Docket No. 72-1008, Certificate of Compliance (CoC) No. 1008

Subject: Submittal of Responses to NRC's 2nd Round RAIs for HI-STAR 100 Amendment Number 3

Second Request for Additional Information

**Docket No. 72-1008
Certificate of Compliance No. 1008
HI-STAR 100 Cask Storage System
Amendment No. 3**

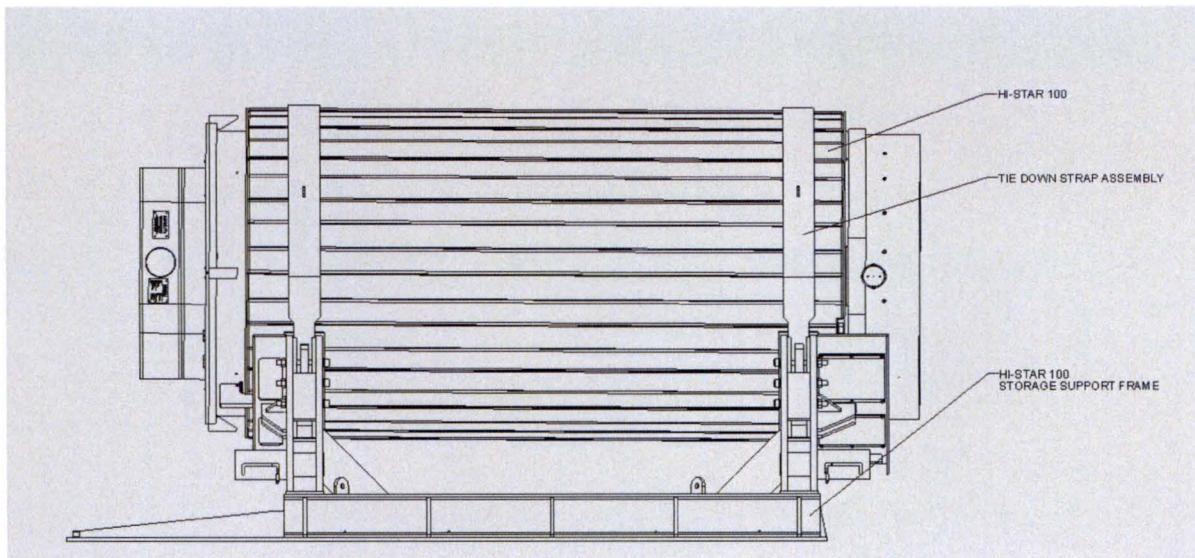
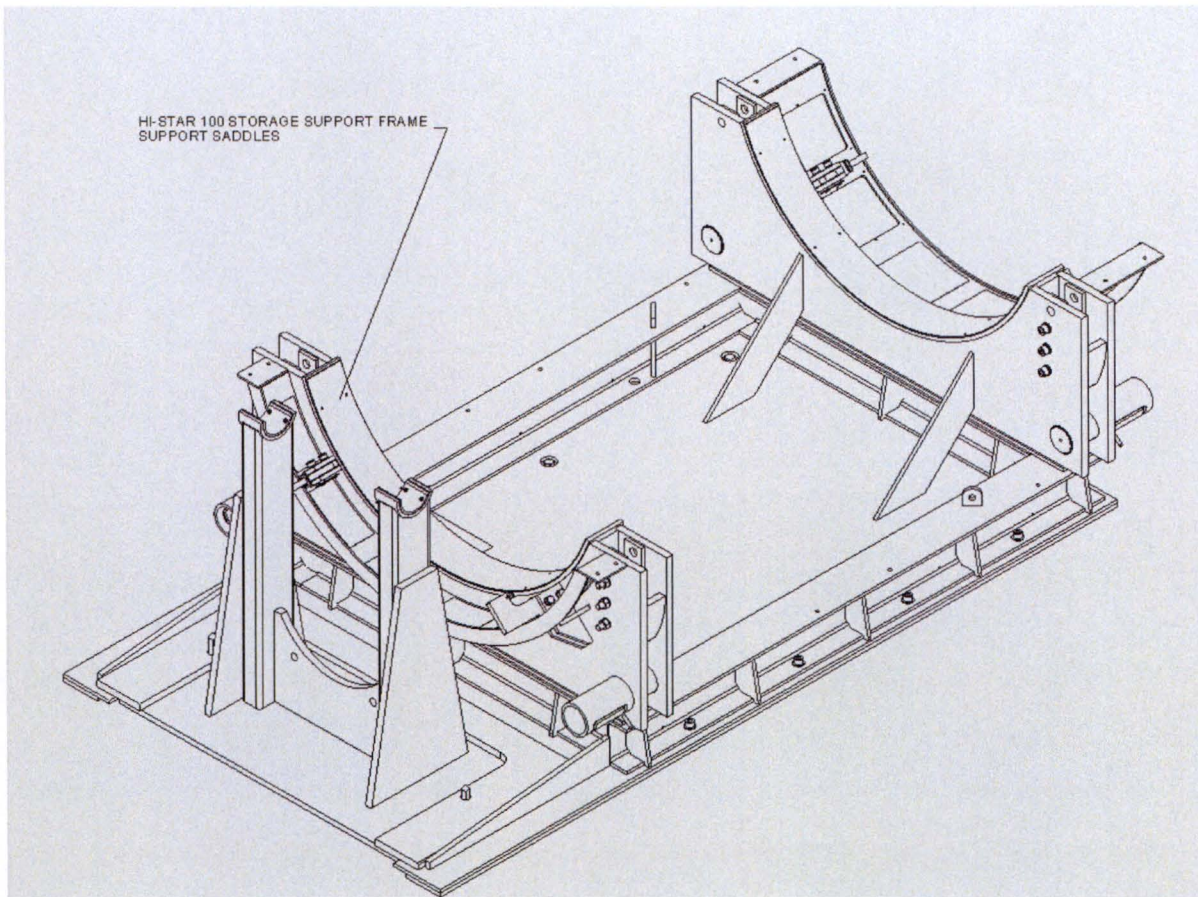
- 4-2** Provide additional discussion, descriptions, more specific incorporation by reference, or thermal analyses, to address how the physical attributes of the horizontal emplacement structure affects the thermal performance characteristics of the HI-STAR 100 Cask Storage System when emplaced in a horizontal orientation, for normal, off-normal, and accident conditions.

In its first RAI, staff sought additional design information for the emplacement structure to be used to maintain the cask in a horizontal orientation. In its response, Holtec stated that it considers the proposed horizontal emplacement structure as not important to safety because it has analyzed the effect of cask drops from a height higher than the proposed height of the horizontal emplacement structure. However, in its response, Holtec does not discuss or evaluate the effects that this horizontal emplacement structure may have on the thermal performance of the cask or if it presents unique boundary conditions that need to be considered.

The staff needs additional information, either through design drawings, detailed descriptions, incorporation by reference, or thermal analyses, to verify that the boundary conditions accorded by the horizontal emplacement structure do not affect the thermal performance characteristics of the HI-STAR 100 in storage. The applicant should ensure that the most bounding MPC type is addressed. Because the horizontal emplacement of the HI-STAR 100 System has not been previously discussed or analyzed by the applicant, the method by which a HI-STAR 100 cask system would be placed on a storage pad at an ISFSI or interim storage facility is not known. The means of emplacement are an important element in determining off-normal and accident conditions that could occur during the movement of the HI-STAR 100 cask system to its storage configuration. Postulated off-normal and accident conditions (including a fire during the movement evolution, or a seismic event during storage, for example) would be different for a cask being placed in a horizontal vs. a vertical storage configuration. The off-normal and accident conditions that could occur during the emplacement of the HI-STAR 100 cask system in a horizontal storage configuration should be considered and analyzed to demonstrate that the cask maintains its safety functions under these conditions. The emplacement structure, and its effect on the cask system, should also be considered in these analyses. If the applicant chooses to provide additional justification or incorporation by reference to address the staff's request, it should ensure that the information provided is thoroughly discussed and/or properly referenced in its proposed FSAR revision. Alternatively, if the applicant chooses to provide additional thermal analyses to address the staff's request, the applicant should submit any associated input and output files with its response.

Holtec Response: In the horizontal orientation for storage, the HI-STAR 100 is supported by saddle-type supports located near the cask's extremities as shown in the following figures. As can be seen from the figures below, the saddles cover on the order of 40% of the cask circumference. Metal tie-down straps wrap around the remainder of the circumference at the same axial locations to secure the cask to the saddles. A tilting plate bolted to the cask base surface assists in rotating the cask from vertical to horizontal, and is left in place afterwards to provide additional gamma and neutron shielding.

The relevant dimensions of the saddle supports and tie-down straps are listed in the following table.

These saddle dimensions shall be used whenever the HI-STAR 100 cask is held horizontally. The above figures and horizontal emplacement structure dimensions will be added to the FSAR.

As can be inferred from the above figure, the configuration of the HI-STAR 100 cask in horizontal storage emulates its configuration in transport, with the notable difference that there is no impact limiters to reduce the rejection of heat from the cask's ends. This deduction is borne out by the Fluent analysis summarized below.

FIGURE 1.4.2; HI-STAR 100 TYPICAL ISFSI STORAGE PATTERN FOR HORIZONTAL STORAGE

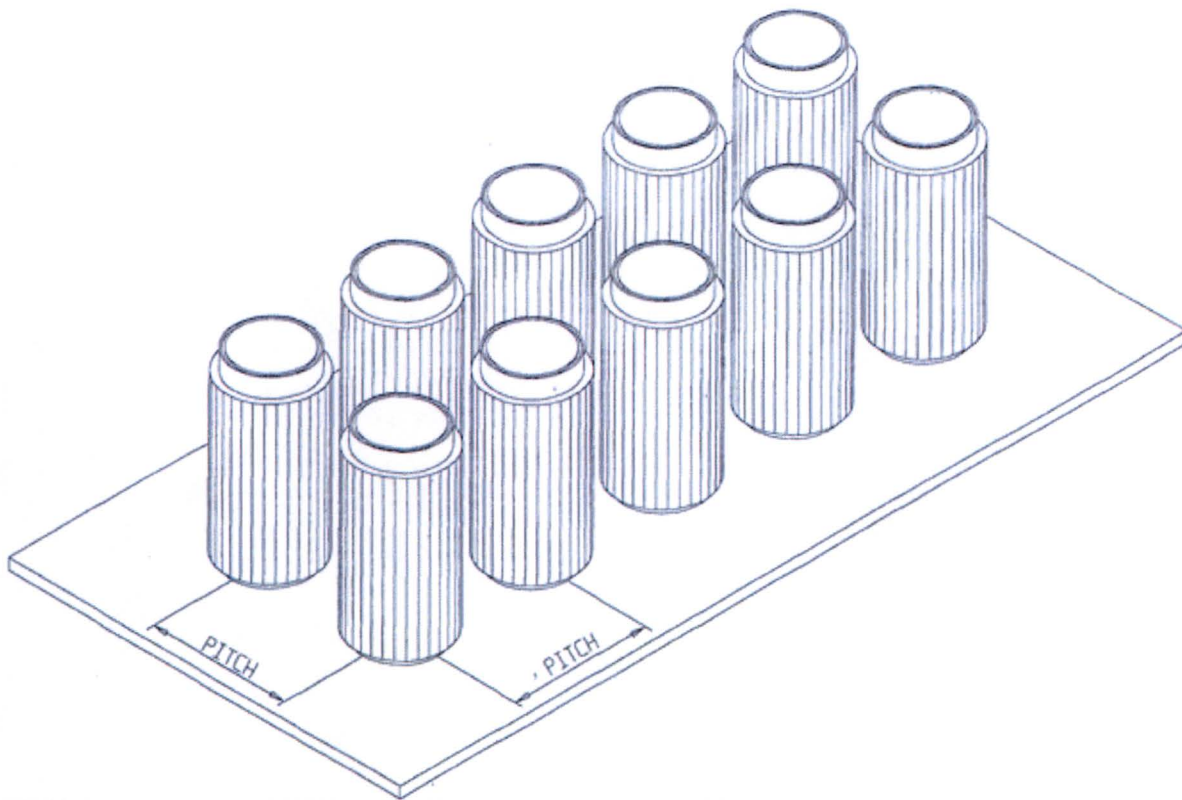
- 4-4** Provide discussion and results of the thermal analysis in Section 4.4.1.1.7 of the FSAR that addresses the thermal interaction among casks in an array that ensures the cask array pitch or center-to-center spacing is bounding for all cask contents/MPCs, considers the most bounding combination of vertical and/or horizontal cask orientation, and provides justification for the most bounding combination of vertical and/or horizontal cask orientation.

The thermal interaction among casks in an array for the most bounding combination of vertical and/or horizontal cask orientation has not been described in Section 4.4.1.1.7, "Heat Rejection from Overpack Exterior Surfaces," of the HI-STAR 100 Cask Storage System FSAR. It is not clear if both horizontally and vertically oriented casks will be mixed, if the calculated cask array pitch (12 feet) is bounding for any combination of cask orientations, or if the minimum spacing is bounding for any type of canister models (e.g. MPC-24, MPC-32, and MPC-68).

Holtec Response: The required minimum cask-to-cask pitch of 12 feet in both orthogonal directions, specified in Section 1.4 of the proposed FSAR, is applicable to arrays of vertically-oriented casks only. For arrays of horizontally-oriented casks, a minimum lateral cask-to-cask pitch of 18 feet and a minimum axial cask-to-cask clearance of 5 feet is proposed (as shown in the following sketch).

Vertically-oriented and horizontally-oriented casks will not be combined within an array, and a separation of at least 18 feet will be maintained between adjacent arrays.

A typical horizontal-orientation ISFSI storage pattern is illustrated in Figure 1.4.2. In horizontal storage, the design-basis lateral distance between cask centerlines is 18 feet (5.5 m) to provide practical access for handling equipment and the design-basis axial cask-to-cask clearance is 5 feet (1.5 m). Site-specific layouts for arrays of horizontal casks are evaluated pursuant to 10CFR72.212.
